HERITAGE PRESERVATION COMMISSION REPORT

Review of Commercial Buildings adjacent to any Designated Historic Building. Section 115-558(g)

PROPOSAL: The applicant is proposing to remove the storefront and install a new entryway on the building located at 201-225 3rd Street N.

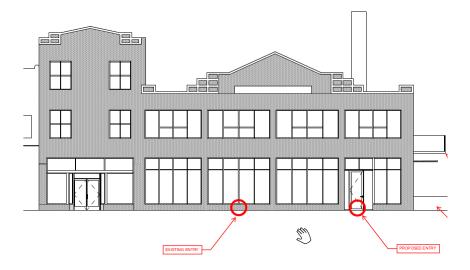
Removal of the existing entryway for windows on 3rd Street is not appropriate. Especially if an inappropriate doorway is being installed just 20ft or so to the north of it.

The proposed changes and alterations on 3rd St N are not appropriate to the building and in maintaining and preserving its historic fabric. Without additional detail it is difficult to make a determination on the proposed alterations to the north façade.

This Certificate of Recommendation is recommended for referral until further details and discussion are held with the applicant.
